# SUPERSTAR CARWASH

## MEADOWBROOK PKWY

Add Site Development Plan title

COVER SHEET

C3.0

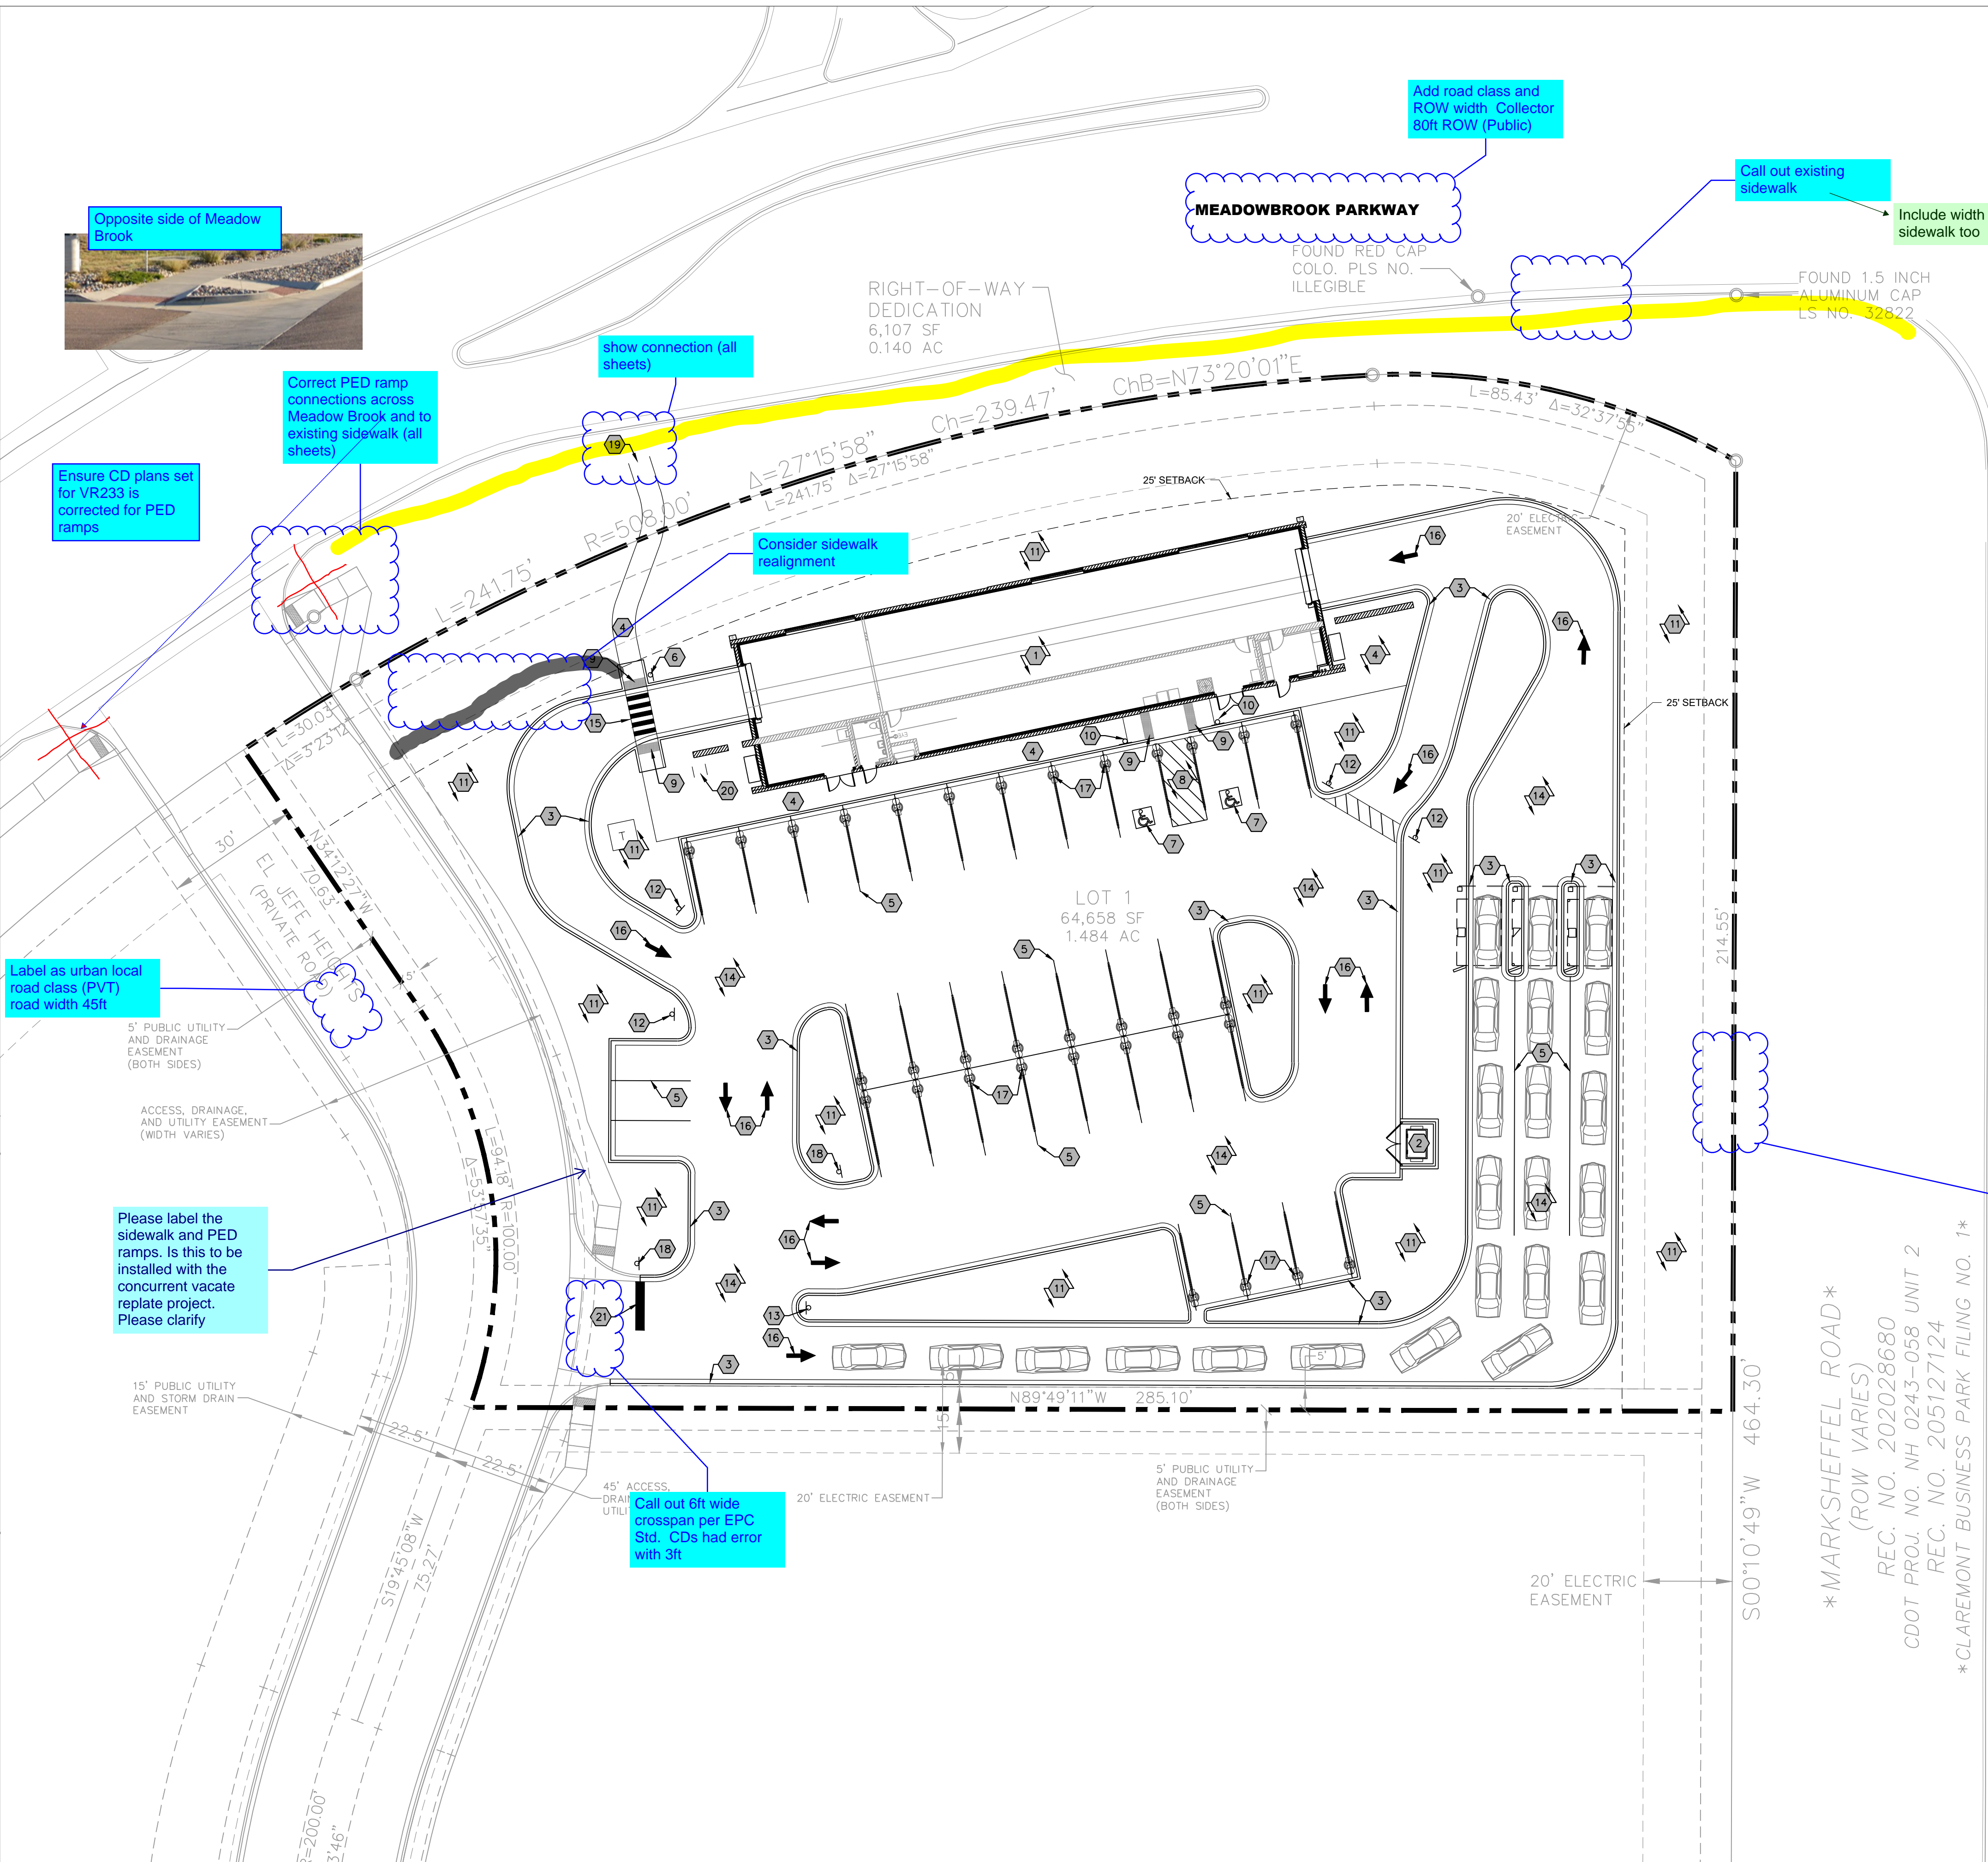
Please show the proposed signs for the cash wash too

Please depict garbage receptacles and screening mechanisms

Any fencing or walls ? please include height

Provide a line legend

Show proposed storm drain system throughout site.

Ensure CD plans set for VR233 is corrected for PED ramps

Label as urban local road class (PVT) road width 45ft

Please label the sidewalk and PED ramps. Is this to be installed with the concurrent vacate replat project. Please clarify

Call out 6ft wide crossspan per EPC Std. CDs had error with 3ft

Add road class and ROW width Collector 80ft ROW (Public)

Call out existing sidewalk

Include width of sidewalk too

Consider sidewalk realignment

Correct PED ramp connections across Meadow Brook and to existing sidewalk (all sheets)

show connection (all sheets)

C4.1

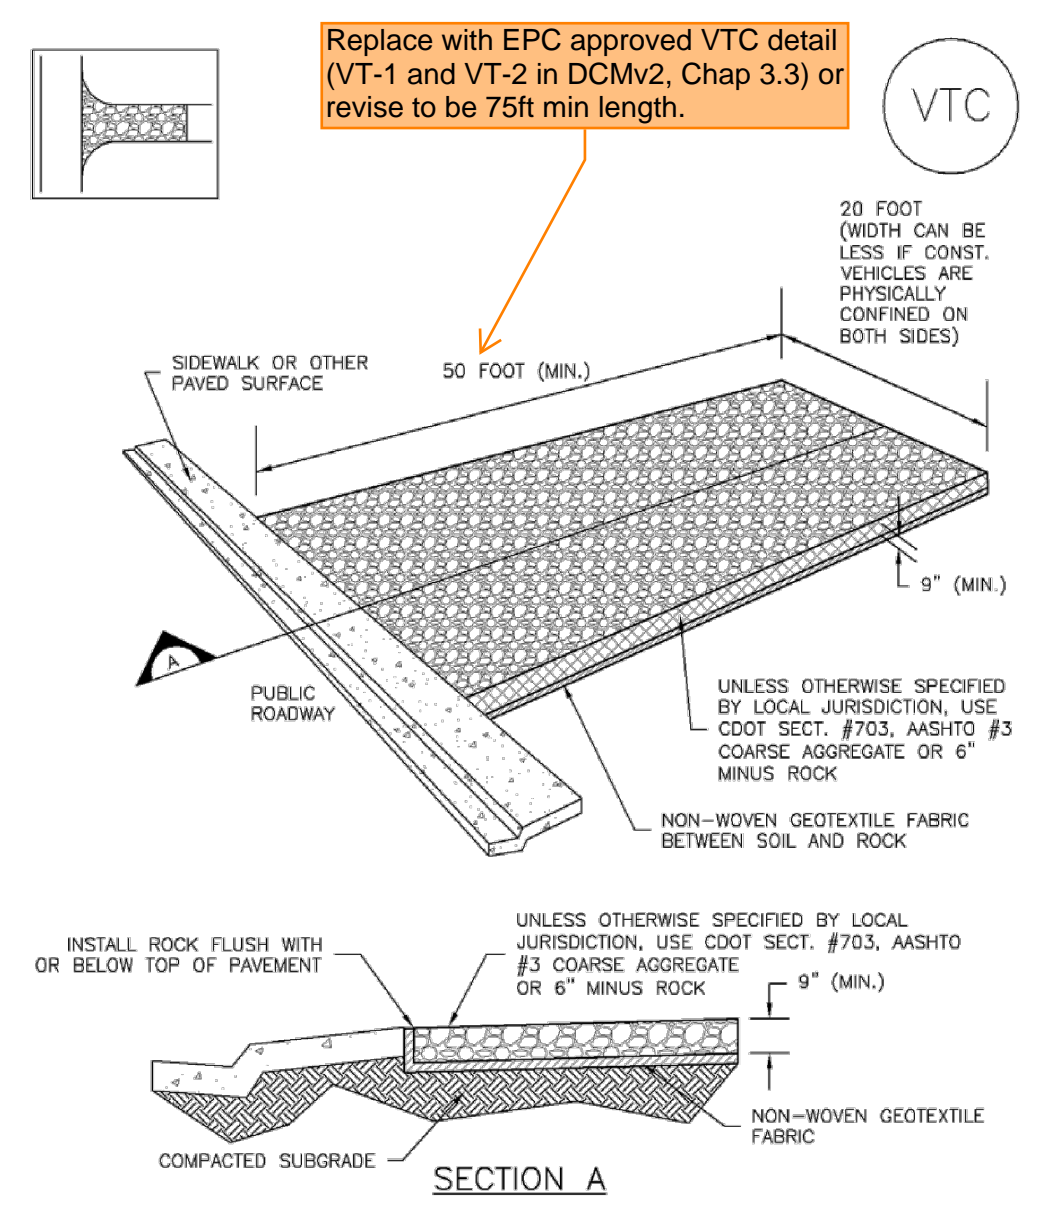
GEC Checklist item z:  
-Add CWA detail.  
-Add staging areas and stockpile management details.  
-Add details for seeding and mulching.

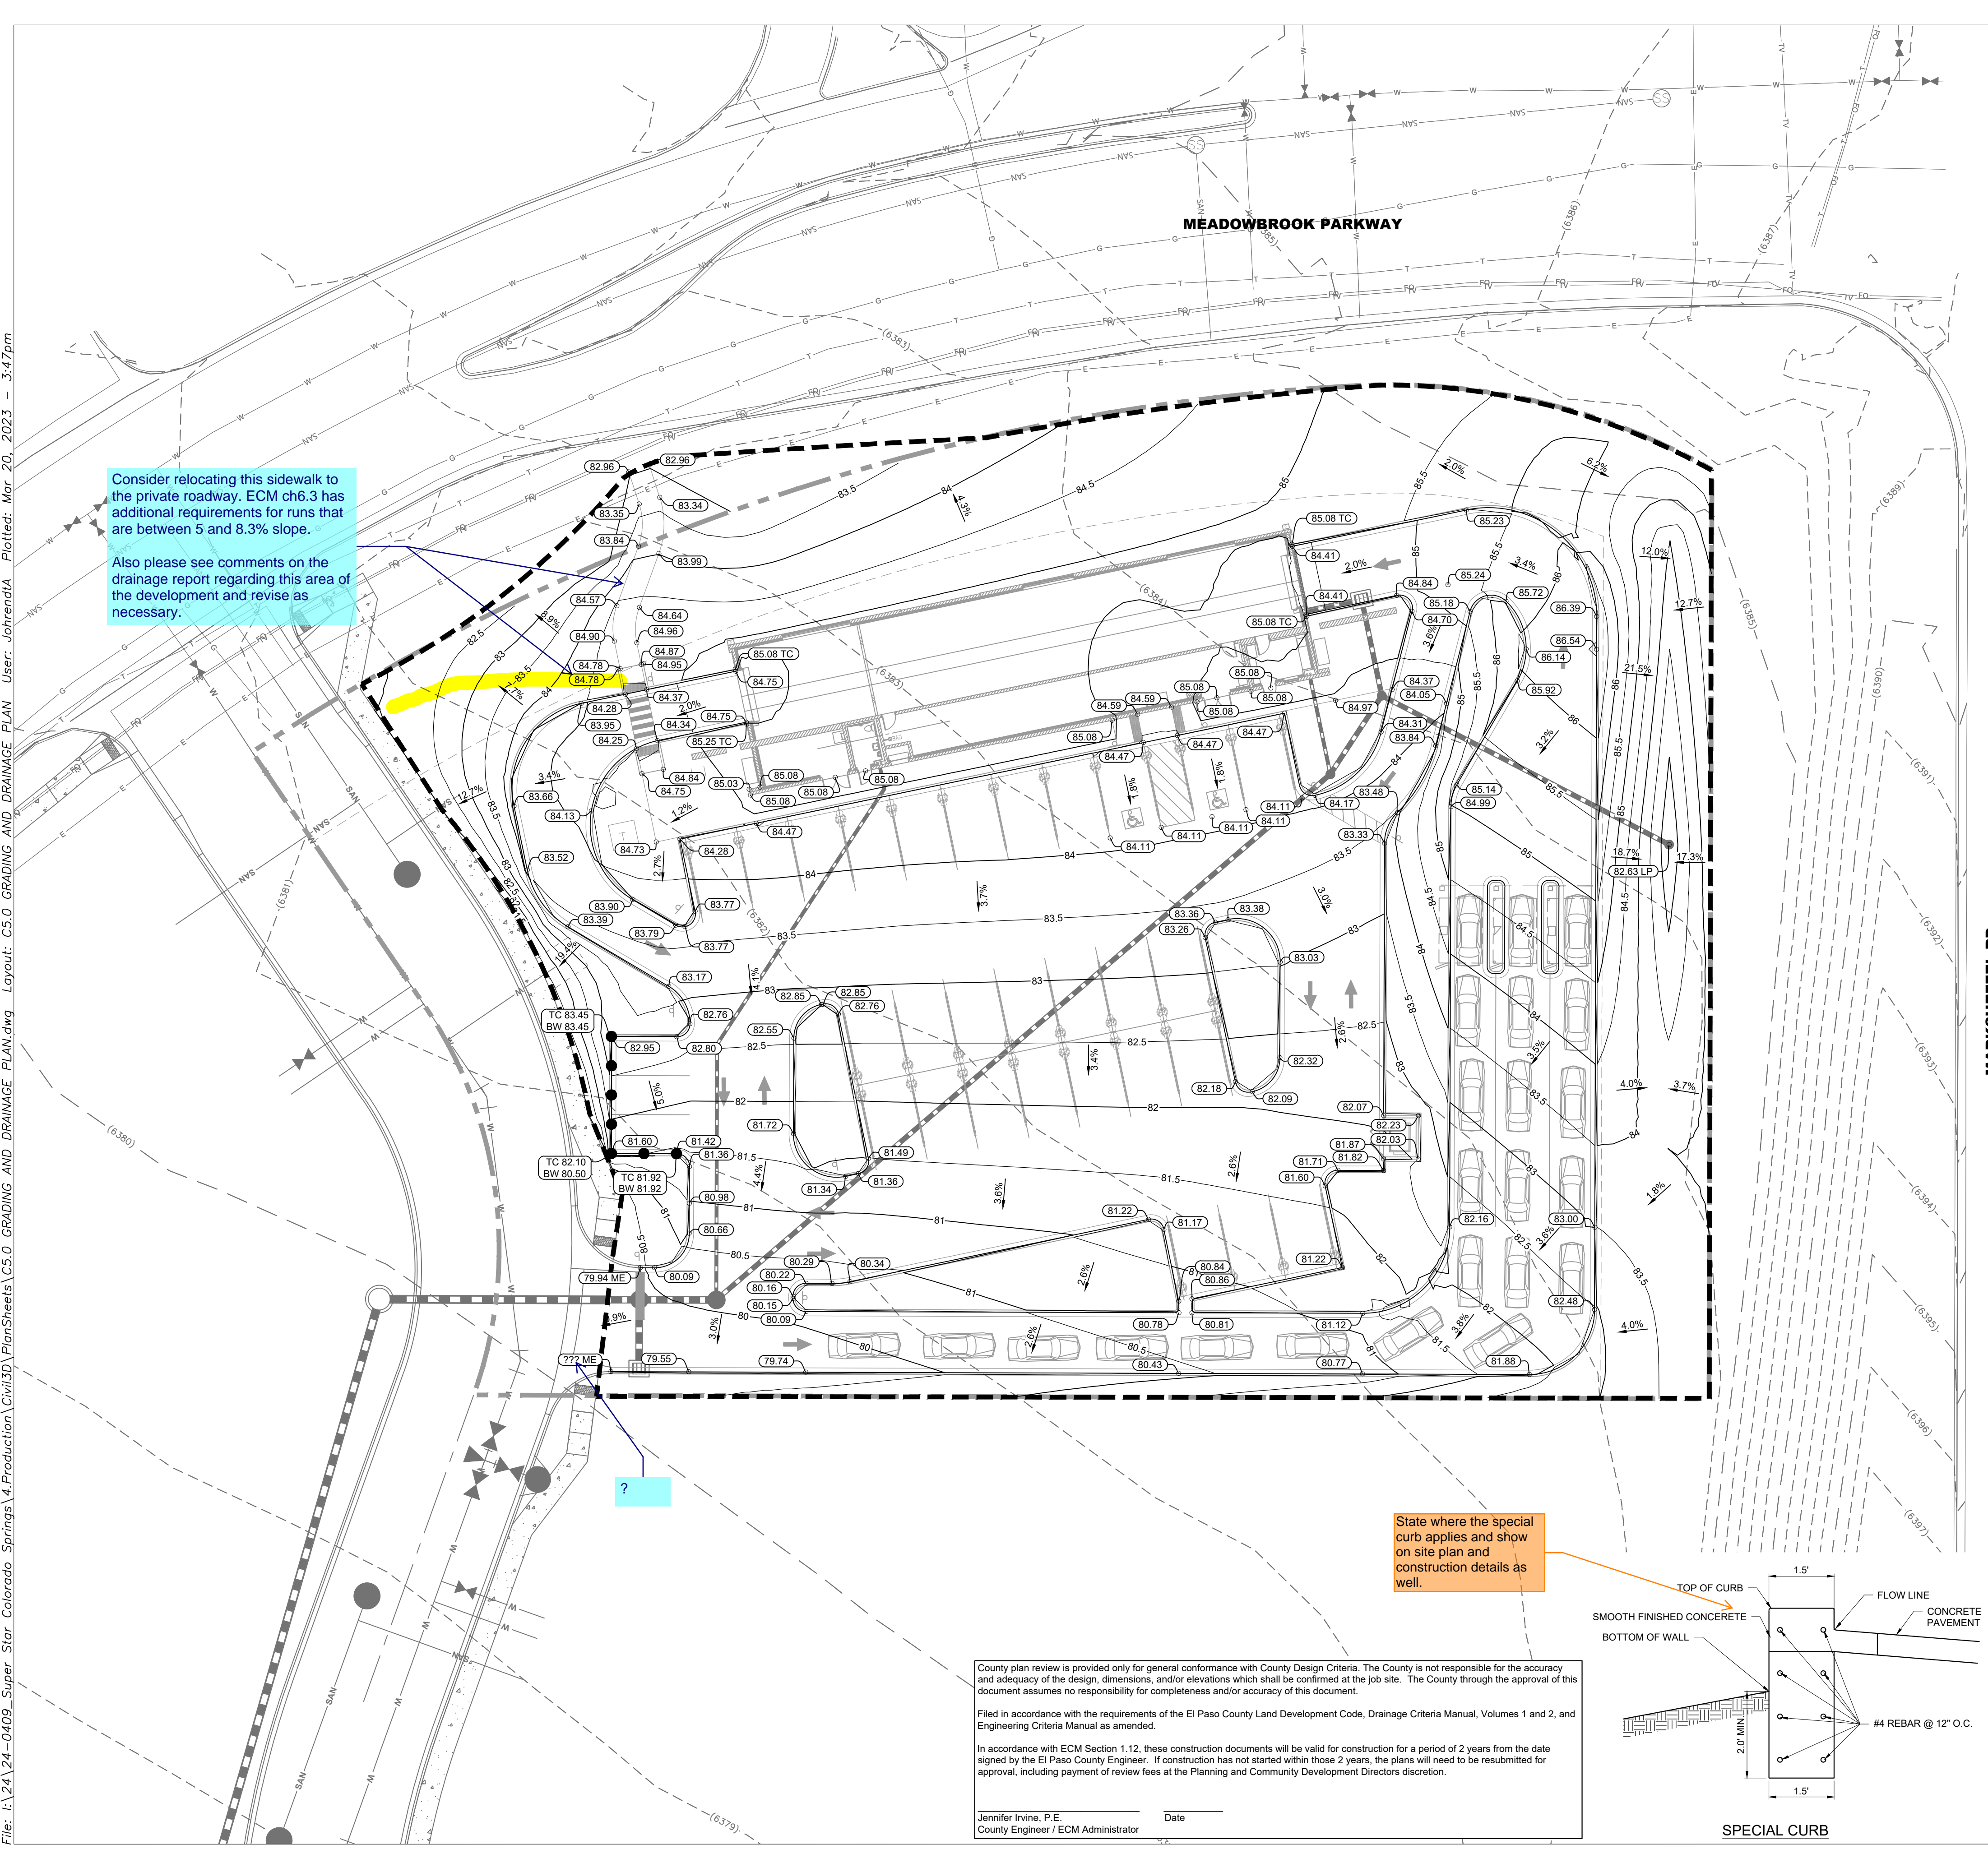
Cut and fill needs to be shown on the plans - add to legend or add cut/fill limits to a new sheet.

Consider relocating this sidewalk to the private roadway. ECM ch6.3 has additional requirements for runs that are between 5 and 8.3% slope.  
 Also please see comments on the drainage report regarding this area of the development and revise as necessary.

State where the special curb applies and show on site plan and construction details as well.
